Design Advisory Board

Tuesday, September 23, 2025, 3:00 PM

To: The Design Advisory Board
From: Mary O'Neil, AICP, Principal Planner
RE: ZP-25-456
Location: 85 Lakeview Terrace
Date: September 23, 2025

To: The Design Advisory Board
From: Mary O'Neil, AICP, Principal Planner
RE: ZP-25-406
Tax ID: 053-3-164-000
Location: 153 Locust Terrace
Date: September 23, 2025

1 ARCHITECTURAL SITE PLAN
SD-00 1" = 10'-0"

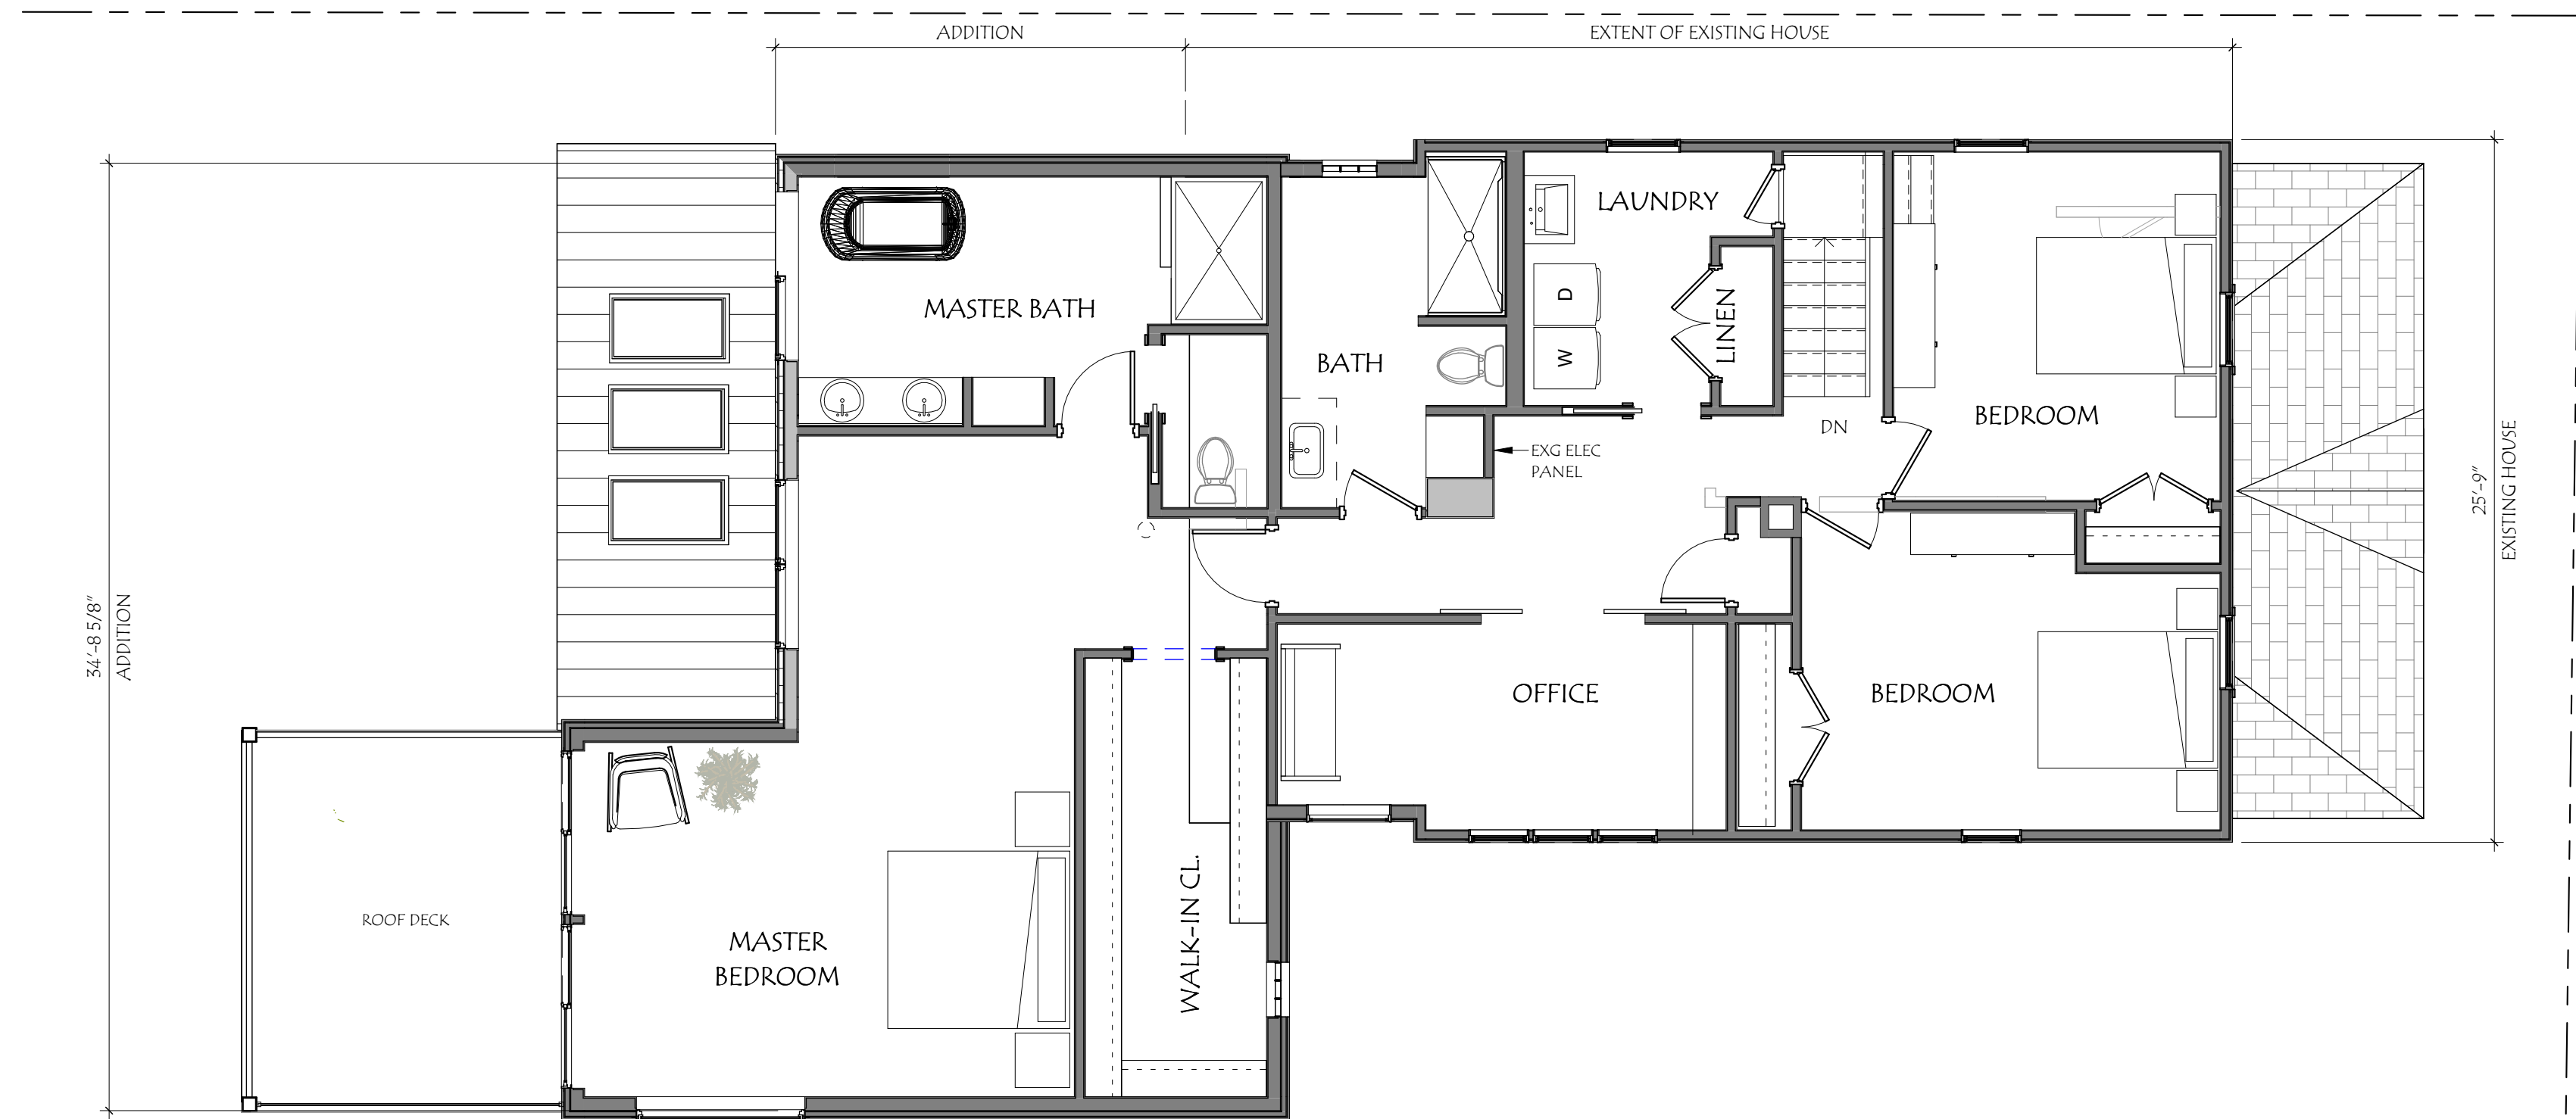
The plan illustrates three parking spaces in an (expanded) driveway. Parking area must meet a minimum 5' setback from property lines; Plan SD-00 appears to show encroachment into that required setback.

Condensing units are required to meet minimum side yard setback of 5'. They need to be illustrated on the site plan to confirm conforming setbacks.

- An EPSC and Stormwater Plan are required.
- A landscaping plan is required
- The bicycle shed, trash, recycling and parking need to observe a minimum setback of 5' from the property line.
- Additional materials are required relative to the Steep Slopes Overlay District. See Section 5.2.4 (b).

- A site plan with building setbacks clearly defined is needed.
- An area for snow storage shall be defined on the site plan.
- There is no evidence that half-walls existed on the front porch. A baluster rail enclosure is recommended. Similarly, turned porch posts should be retained.

PROPOSED EXTERIOR ELEVATIONS

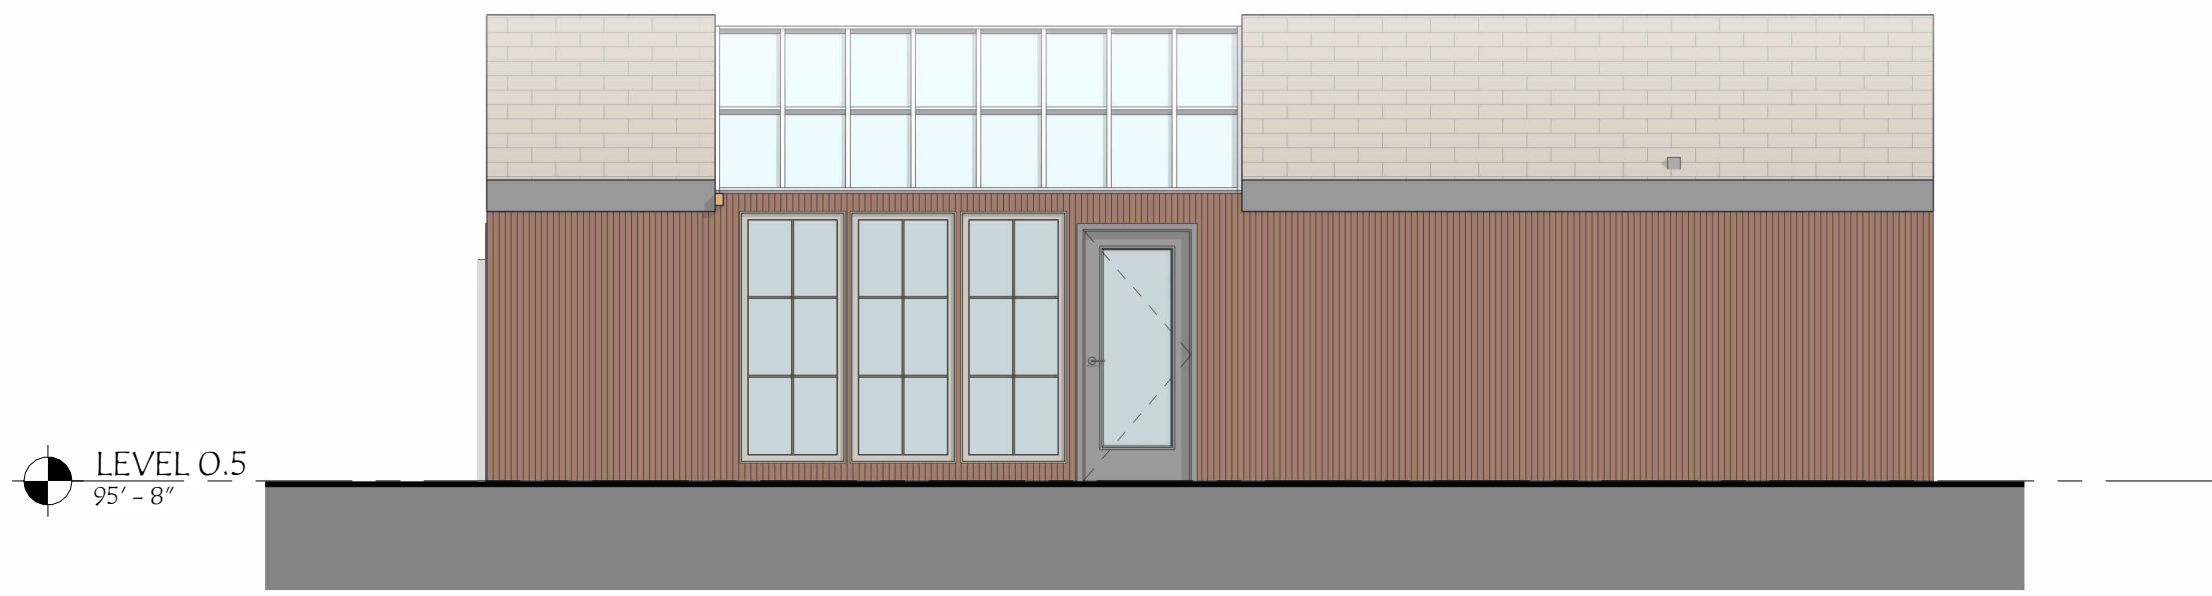
The plan would be enhanced by providing a new entrance to the kitchen addition via the *east elevation* (visible from the street) rather than the south elevation, where it is lost in the expanse of wall. The plan to erect a fence between the driveway and the addition, and then to provide simply a glass block building opening "deadens" the building front and literally closes off the

new structural addition from the street. An entry at this location would additionally provide easy access to the driveway and potentially bike storage.

There are no new design elements to provide protection from the affects of rain, snow and ice at building entrances. The opportunity is lost at the east elevation of the new addition, where vertical windows (entirely unrelated to the existing building) are proposed. Each of these is proposed within “lost” space: a closet and a stairwell. Creating an entrance at this location, and finding a window that provides a counter-point to the existing house on the 2nd level would enliven the streetfront and enhance the design which currently is flat and uninteresting (particularly as it is proposed to be hidden behind a shed and fence.) Much improvement could be made to the design here.
